AMENDMENTS TO THE DRAWINGS

REMARKS/ARGUMENTS

Appln. No. 10/712,764
Amdt. dated March 14, 2005
In response to Office action mailed Dec. 14, 2004

FIG. 6

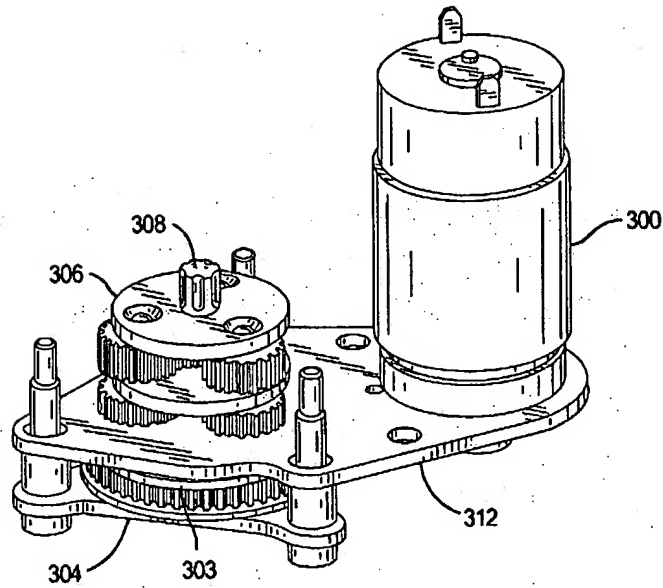
Finally, the drawings were objected to because FIG. 7 is turned sideways to the view in FIG. 3, and FIG. 6 is turned upside to the view of FIG. 3. Applicants respectfully submit that the orientations of the various figures have been selected to best illustrate various aspects of an actuator consistent with the disclosed subject matter. Additionally, Applicants believe that a person having ordinary skill in the art should be able to recognize the changes in orientation and appreciate the corresponding attributes of the various drawings. Applicants respectfully submit, therefore, that no changes to the drawings are necessitated by the selection of view chosen for the various figures. It is respectfully requested that this objection be withdrawn upon reconsideration by the Examiner.

FIG. 8

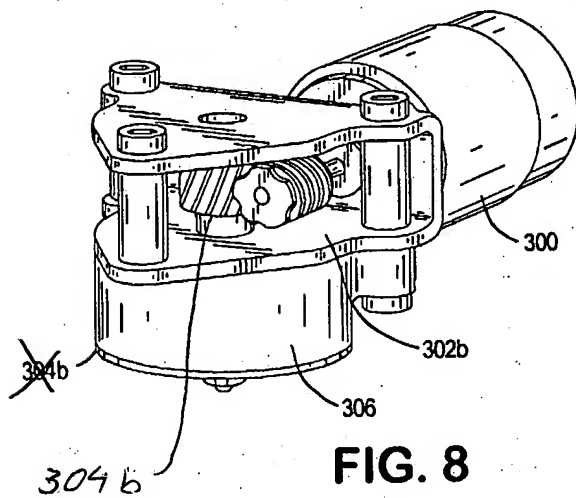
The attached sheets of drawings include changes to FIG. 7 and FIG. 8. The first sheet, which includes only FIG. 7, replaces the original sheet, which also included only FIG. 7. In FIG. 7, previously omitted phantom lines, showing the assembly of the exploded view, have been added. The second sheet includes FIG. 6 and FIG. 8. In FIG. 8, the leader line from reference numeral 304 has been amended to indicate the worm wheel, referenced in the specification.

In the specification, the paragraph beginning on page 8, line 21 has been amended to replace the reference numerals 202b and 204b with the reference numerals 302b and 304b as shown in FIG. 8 of the drawings. No new matter is believed entered by this amendment.

The drawings were also objected to because reference numerals 202b and 204b, recited in the specification, are not included in the drawings. The specification has been amended on page 8, line 21 to correct the minor clerical error whereby the reference numerals were misstated. Page 8, line 21 of the specification has been amended to properly recite “a worm gear 302b and worm weal 304b” as indicated in FIG. 8. No new matter is believed entered by this amendment. Applicants respectfully request that this objection to the drawings be withdrawn upon reconsideration. Furthermore, FIG. 8 has been amended to extend the leader line of reference numeral 304b to more clearly indicate the worm wheel. This aspect of the drawing was clearly shown in the originally filed informal drawings. Accordingly, no new matter is believed entered.
